Docket No. 50-213
B14779

Haddam Neck Plant

Proposed Revision to Technical Specifications

Pressure Temperature Limits - Retyped Pages

FIGURE 3.4-3
HADDAM NECK LIMIT CURVE FOR HYDROSTATIC AND LEAK TESTING FOR 22 EFFECTIVE FULL POWER YEARS

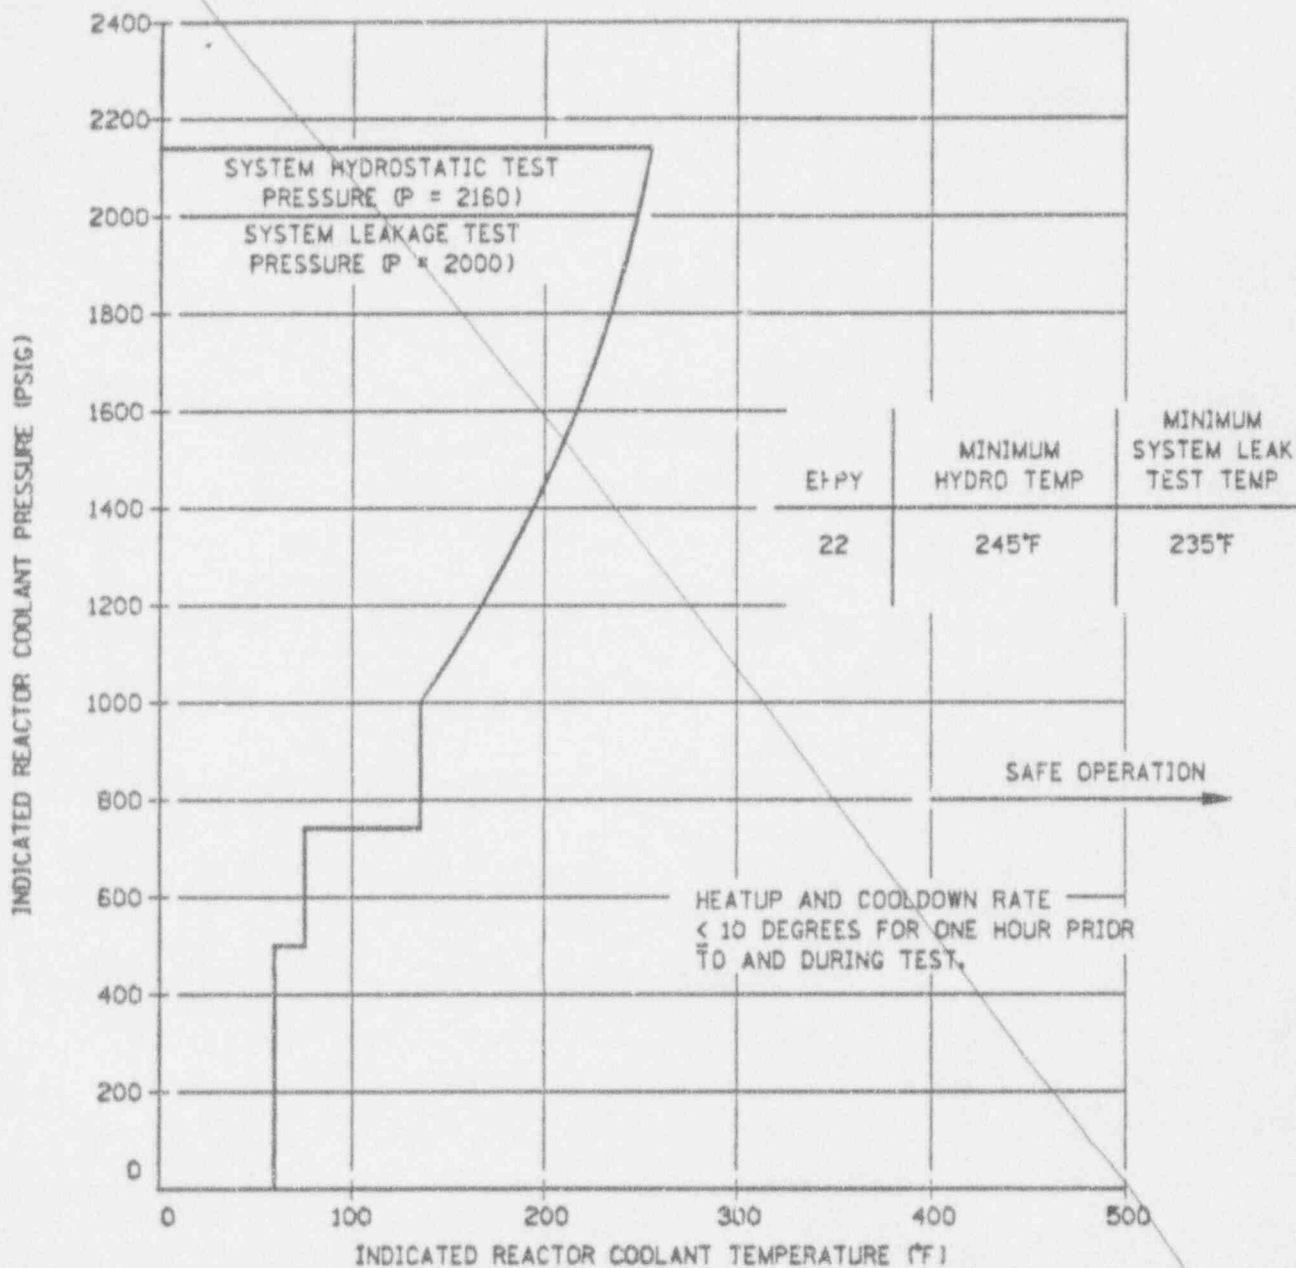
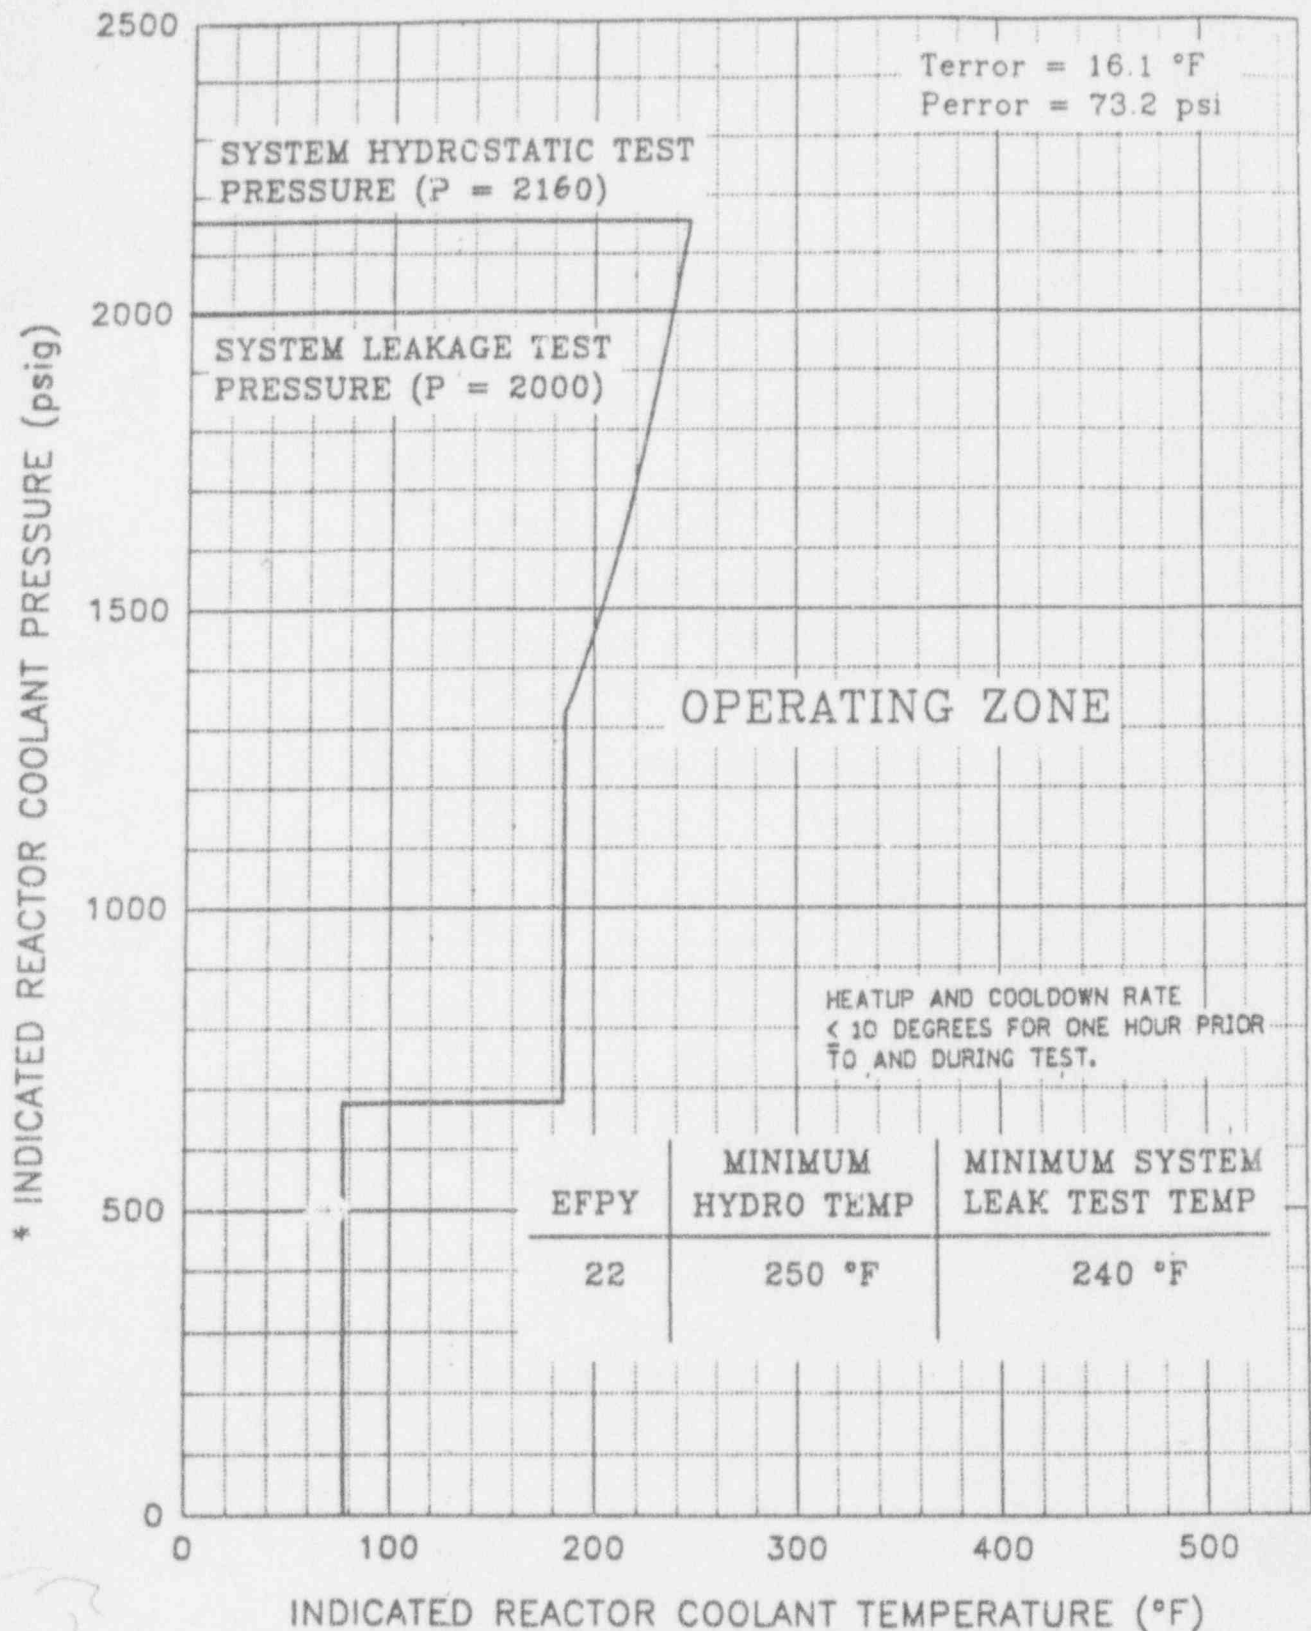
REPLACE

FIGURE 3.4-3
 CONNECTICUT YANKEE LIMIT CURVE FOR HYDROSTATIC AND LEAK TESTING
 APPLICABLE FOR 22.0 EFFECTIVE FULL POWER YEARS.
 (T ERROR = 10°F, P ERROR = 60 PSIG)

New

*AS INDICATED BY THE WIDE RANGE PRESSURE TRANSMITTERS

FIGURE 3.4-4
HADDAM NECK REACTOR COOLANT SYSTEM HEATUP
LIMITATIONS FOR 22 EFFECTIVE FULL POWER YEARS

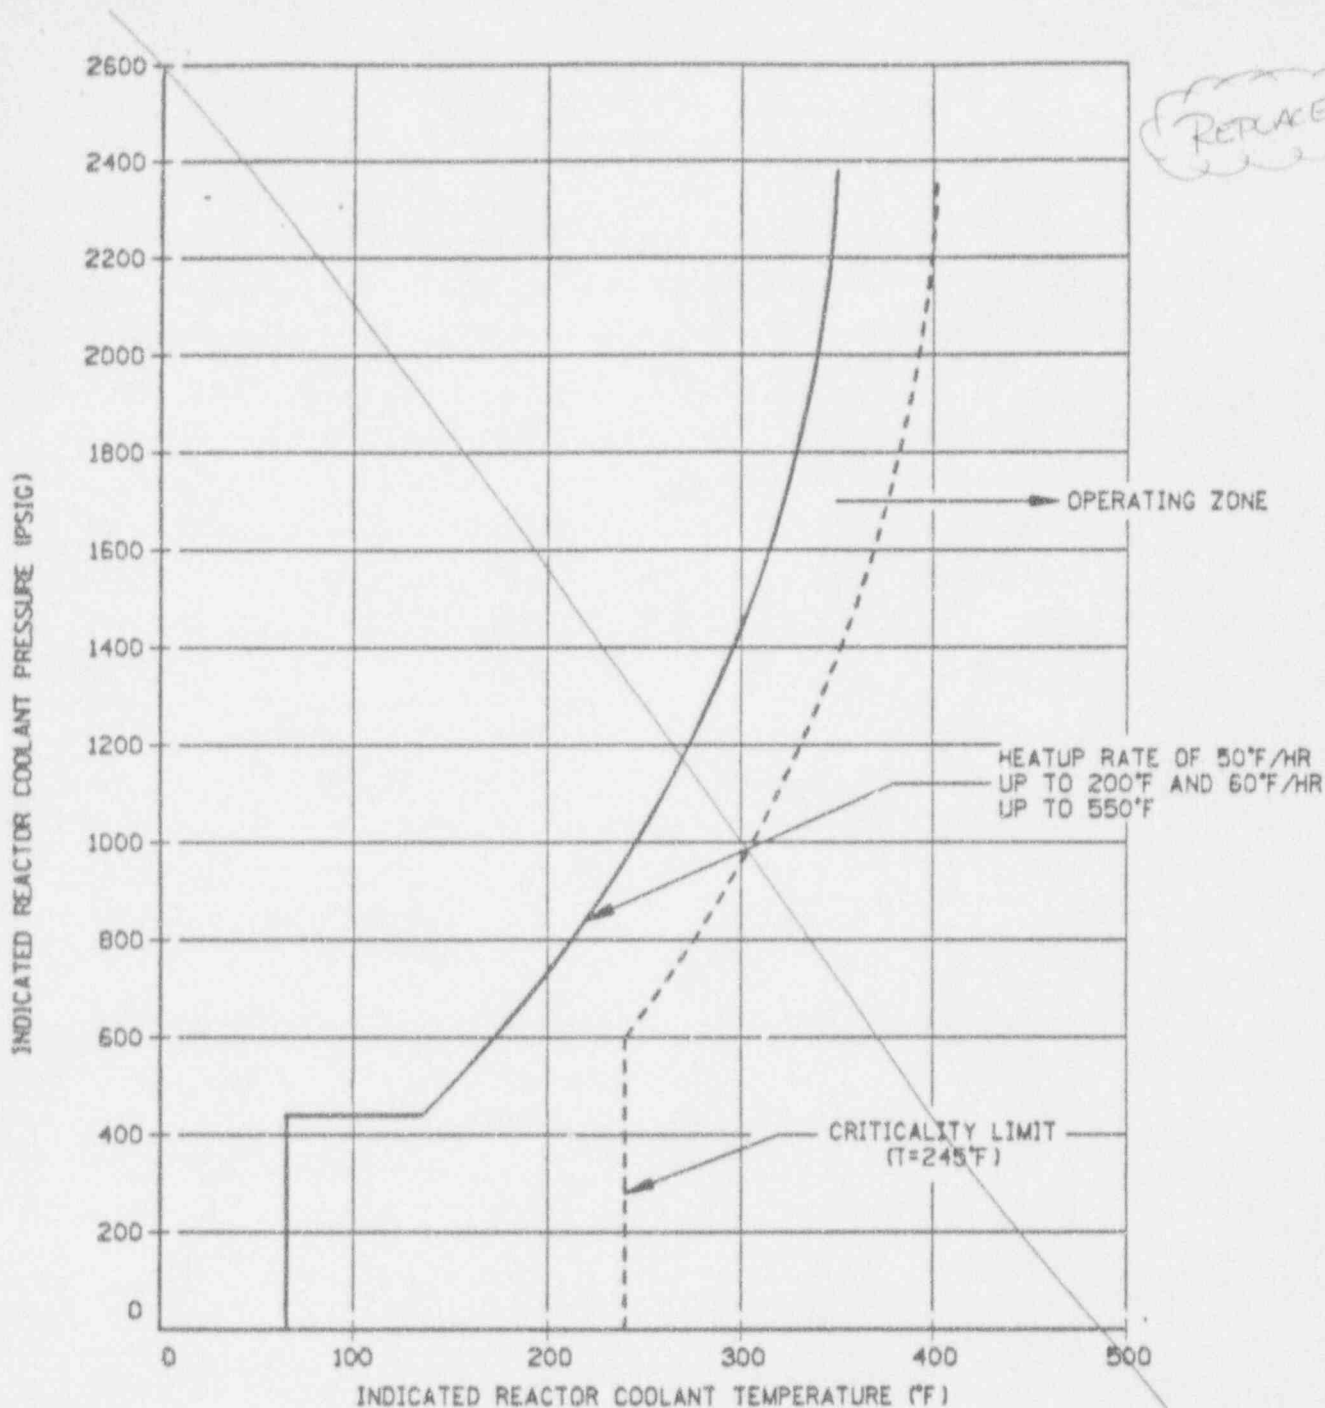
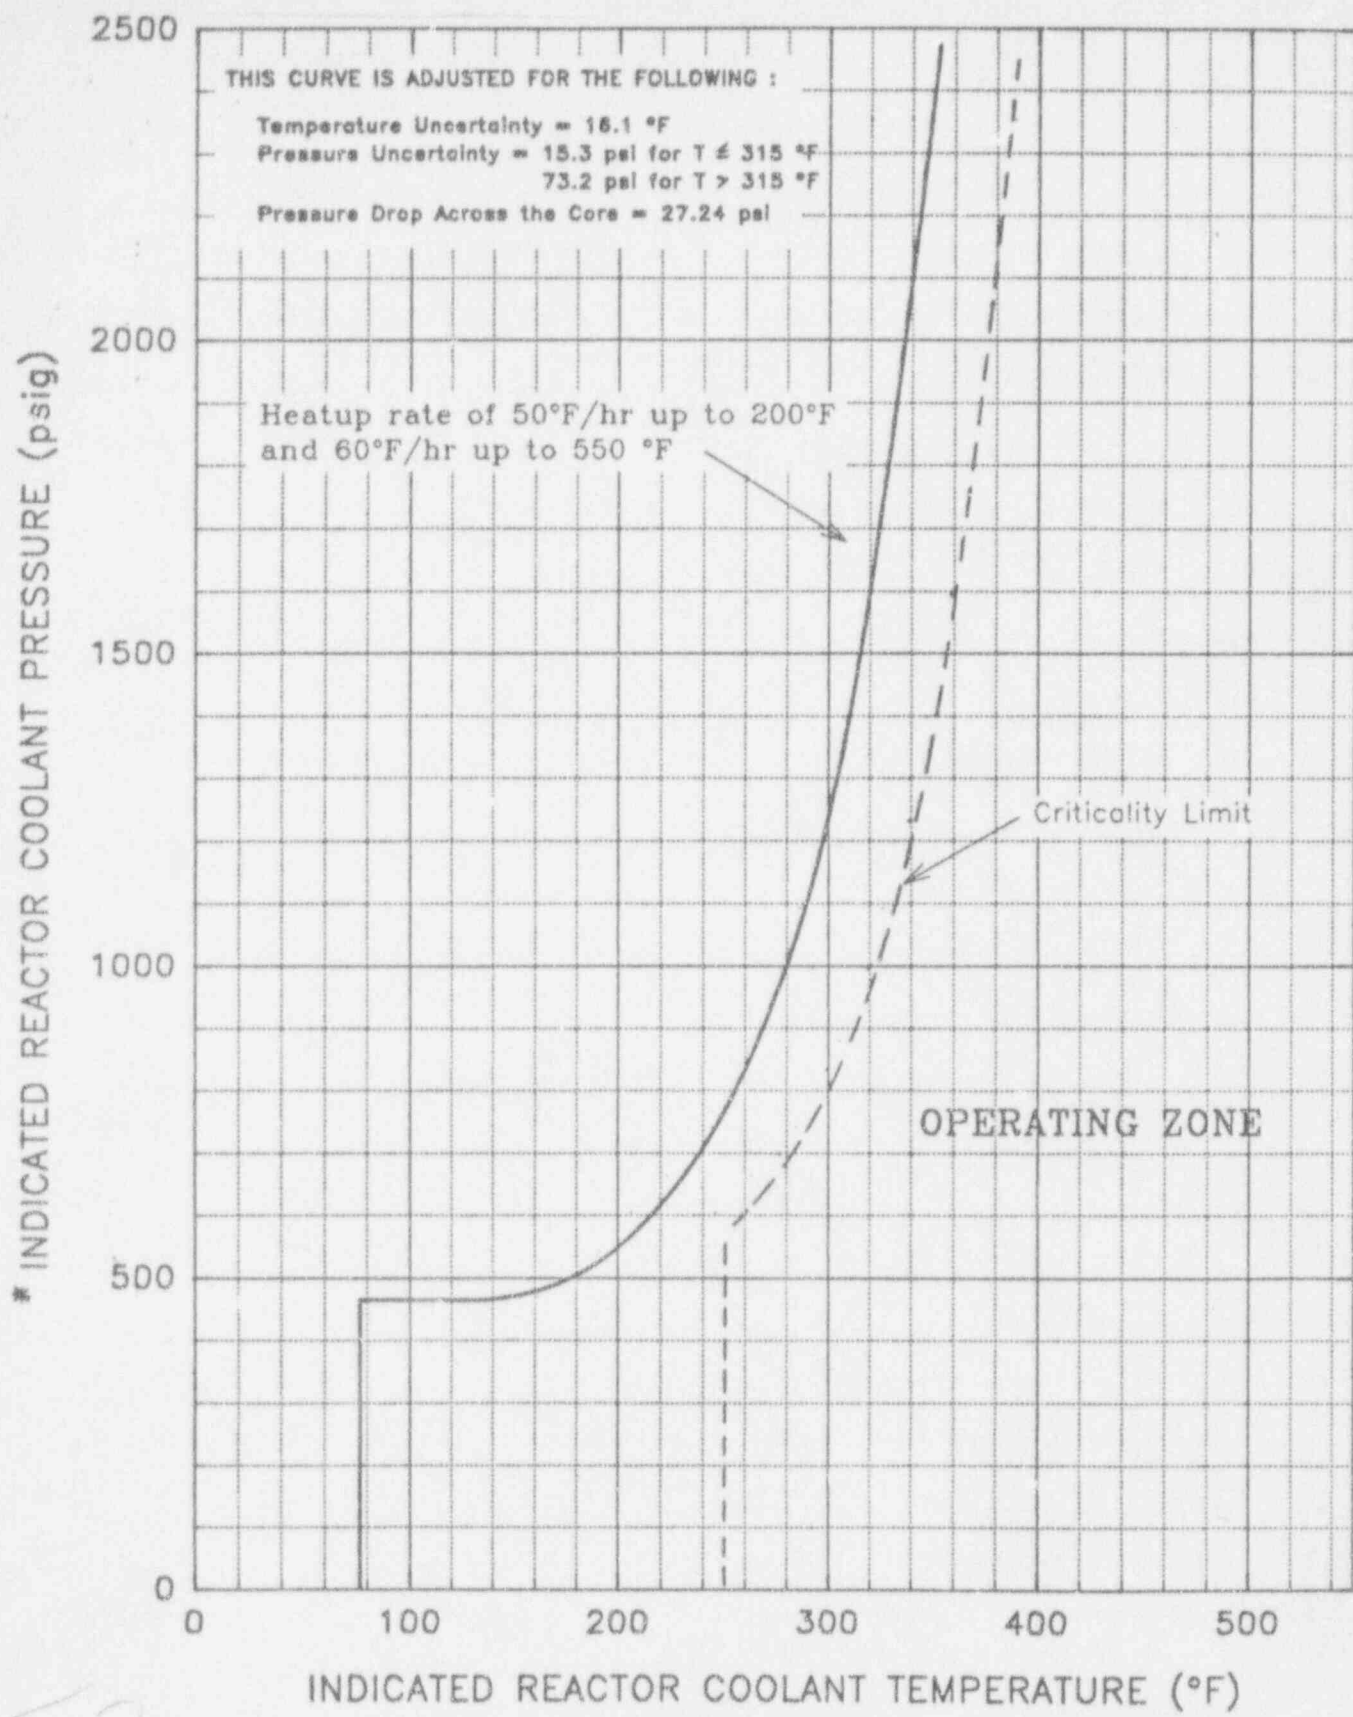
REPLACE

FIGURE 3.4-4
CONNECTICUT YANKEE REACTOR COOLANT SYSTEM HEATUP
LIMITATIONS FOR 22.0 EFFECTIVE FULL POWER YEARS
(T ERROR = 10°F, P ERROR = 60 PSIG)

*AS INDICATED BY THE NARROW RANGE PRESSURE TRANSMITTER FOR $T \leq 315$ °F AND THE WIDE RANGE FOR $T > 315$ °F
